**B9 Paper Mill**

Orora

**Submission Report - Modification #5**

29 May 2015

Stage 1 Mitigation - 7.5 m container wall plus earth mound

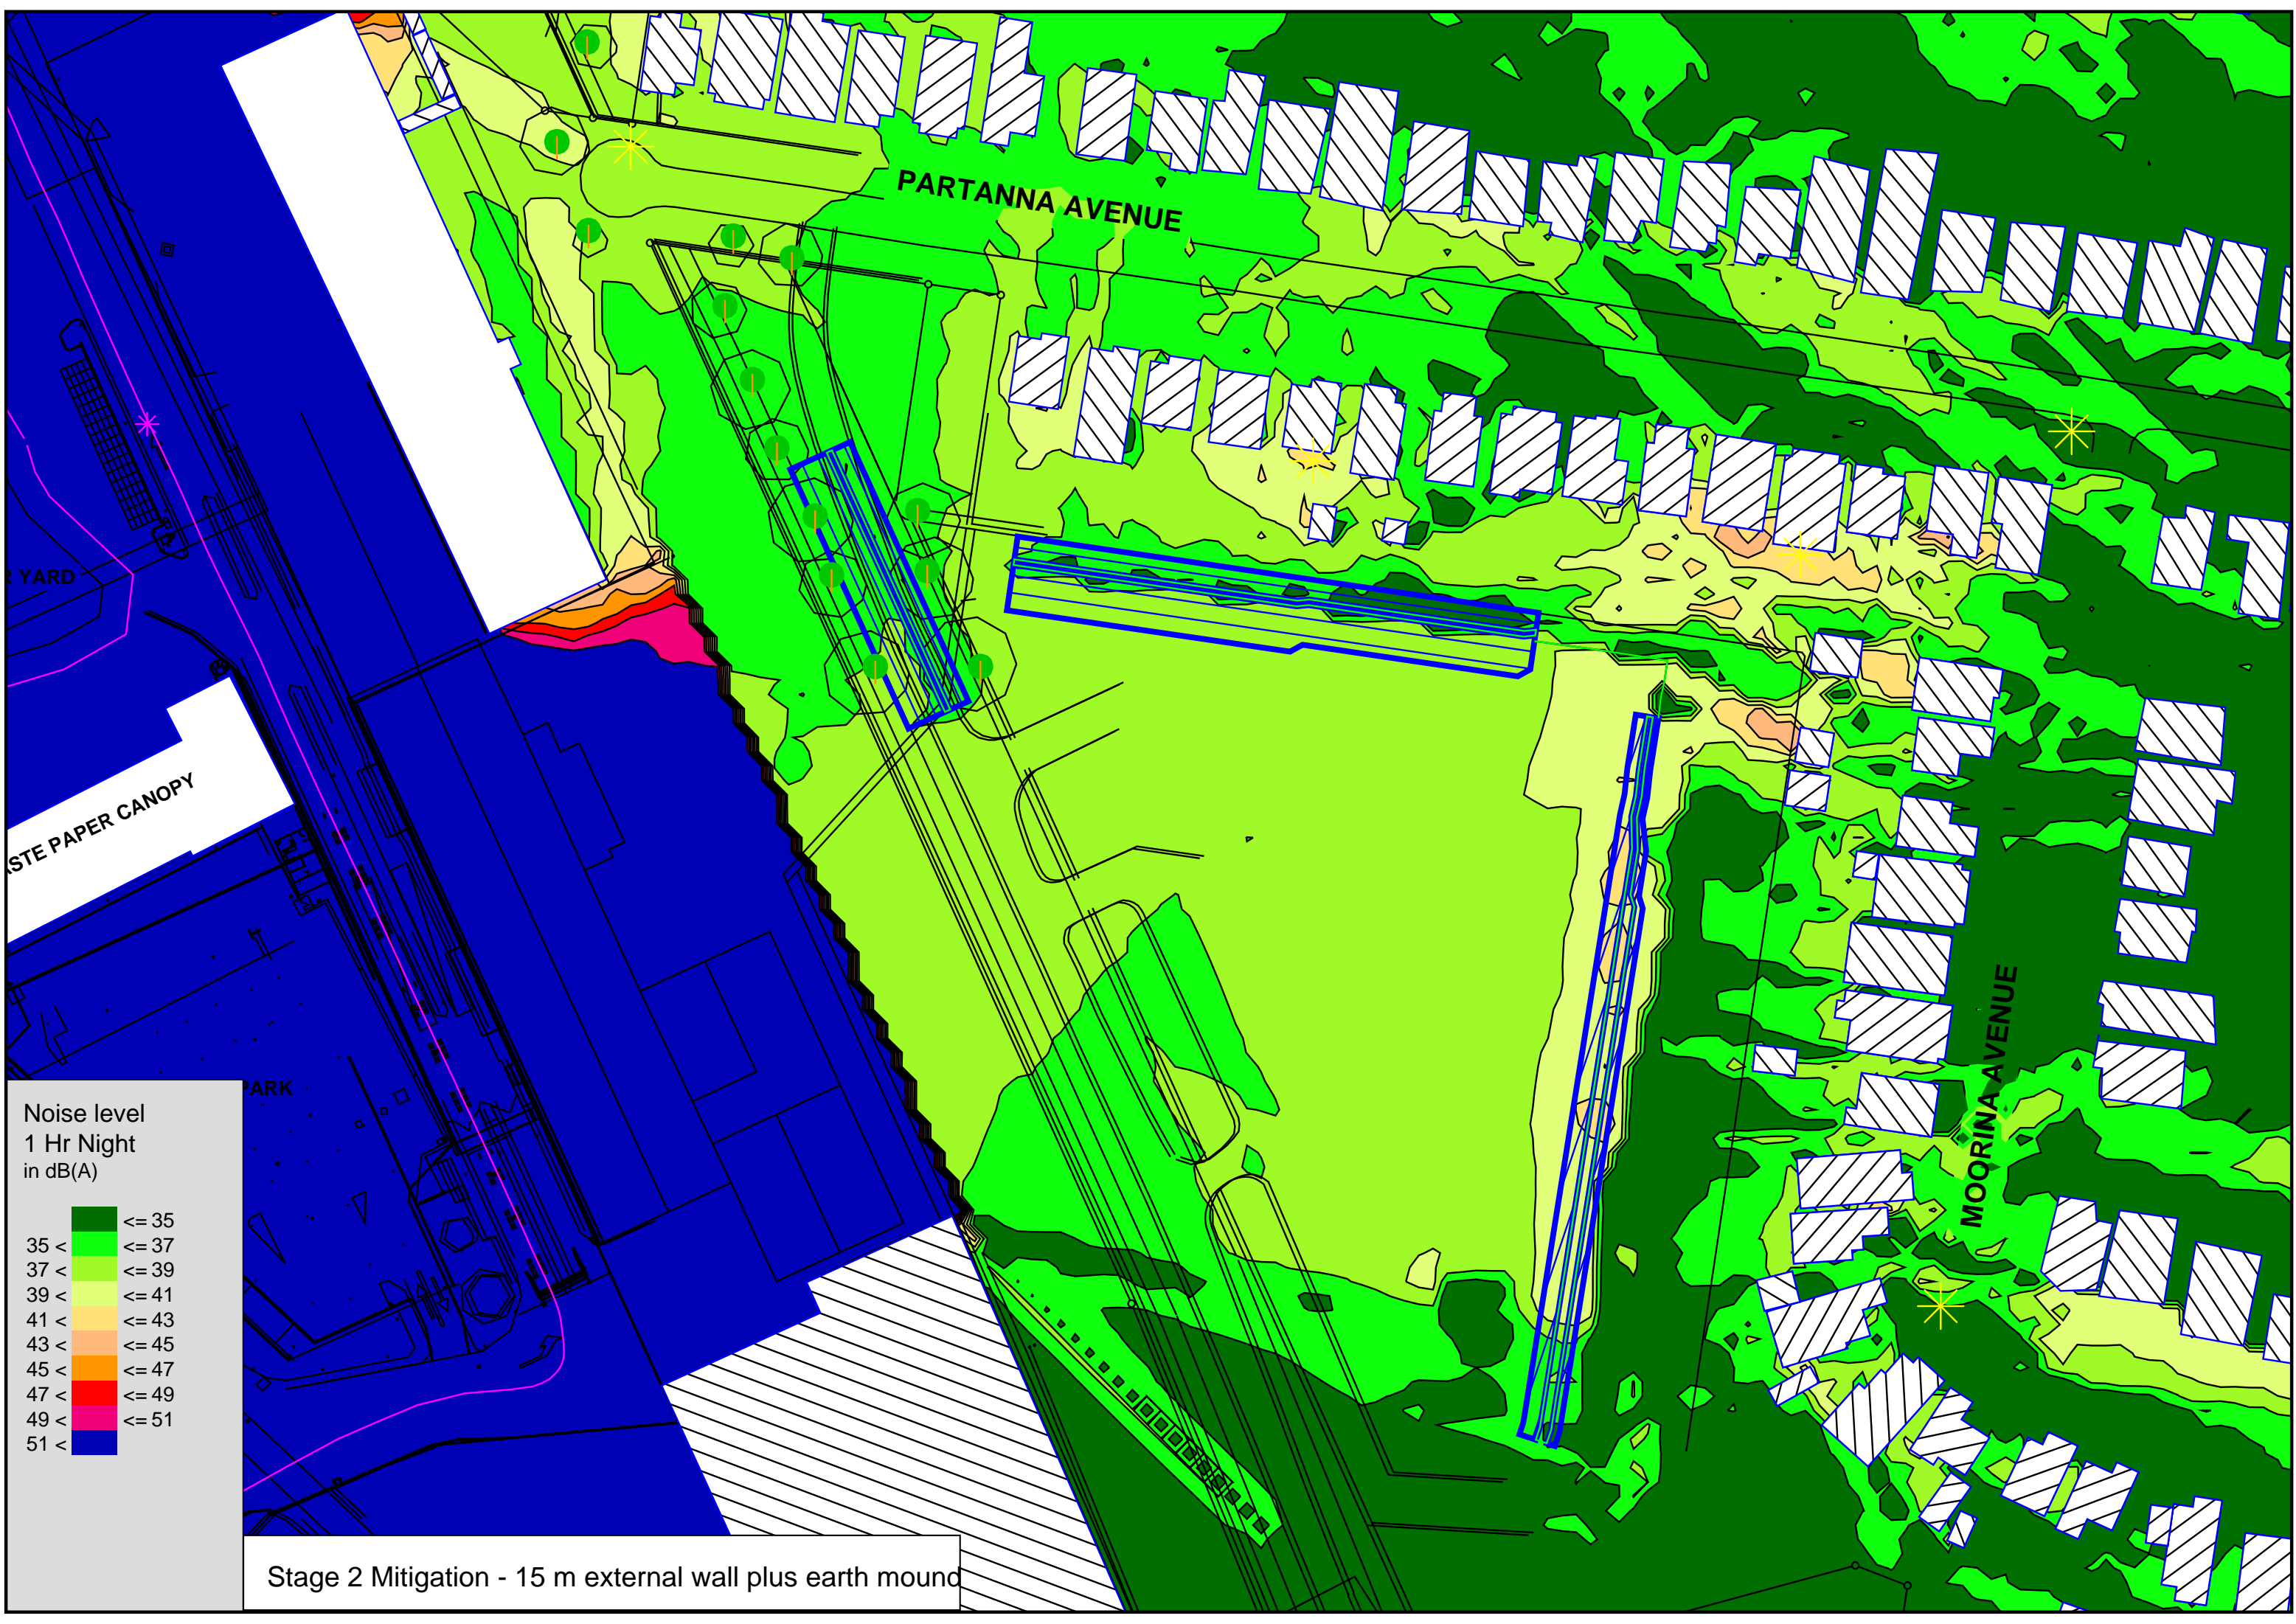
<p>Additionally, the EPA is concerned that the community will be subject to elevated noise levels during the period between removal of the B7 building and completion of the noise wall (if this is found to be feasible). Accordingly, the EPA requests that a clear timeframe is provided for the noise wall survey and feasibility studies, additional noise monitoring and Noise Barrier Design Plan</p>	Section 4 - Noise
<b>Community #1</b>	
Requests that the noise wall be constructed before the demolition of B7 building commences to mitigate demolition noise and dust – as well as providing operational noise mitigation.	Section 4 - Noise
Requests that the existing noise wall be extended along the boundary of the site from Australia to Botany Road	Section 4 – Noise
Requests that the brick wall along Purcell Park be rebuilt as soon as possible to mitigate visual impacts	Section 5 – Visual

To mitigate the impacts of demolition noise and to provide noise mitigation for sensitive receivers between the removal of the B7 building and the construction of the final noise walls, Orora is proposing an interim solution.

Orora have already constructed earthen noise mounds on the Hanger Block as barriers behind residences in Partanna and Moorina Avenue. These mounds currently extend behind several residences at the western end of Partanna Avenue and the north-western end of Moorina Avenue. The extent and location of these earth mounds are currently limited by the existing topography and the existing services/water course through the Hanger Block.

To further reduce the direct noise emissions from the Orora site, additional container walls would be installed on the Hanger Block, adjacent to the Ausgrid easement. The positioning of the containers in this location indicates a direct reduction of operational noise from within the site.

The combination of noise mounds and container wall would be an interim solution until the final noise wall is constructed. The interim solution would not achieve Orora's noise criteria at all sensitive receivers, however, would provide significantly better noise mitigation than no interim noise mitigation as was proposed in the Modification Report. Predicted noise levels at relevant sensitive receivers are presented in Appendix B – Stage 1.
